Video Products Technical Bulletin 30-2004-075

SUBJECT: REUSE ICs WHEN REPLACING THE A BOARD

MODEL: PVM-1340
 PVM-1341
 PVM-1342Q
 PVM-1343MD
 PVM-1344Q
PVM-1440QM
PVM-1442QM
PVM-1443MD
PVM-1444QM

Figure 1

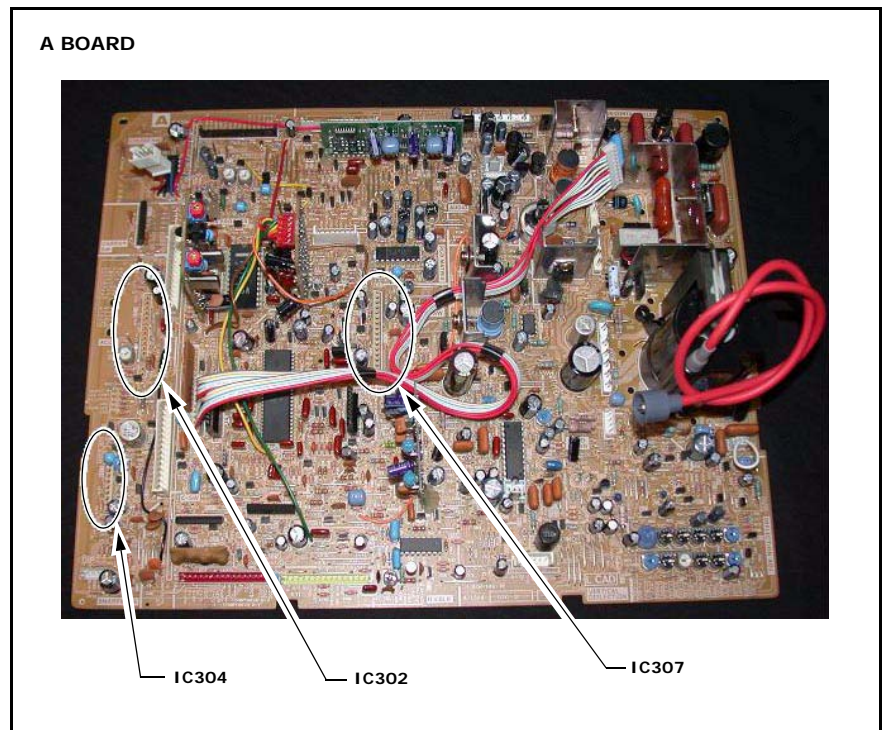
When you replace the A board (A-1296-520-A), remove the following ICs from the former board and install them on the new board.

IC	Function
IC302	ACC block ACC-1
IC304	Picture quality control module
IC307	Blue-only module BOM-1A

The new A board does not contain the ICs, and the ICs are no longer available as service parts. (See Figure 1.)
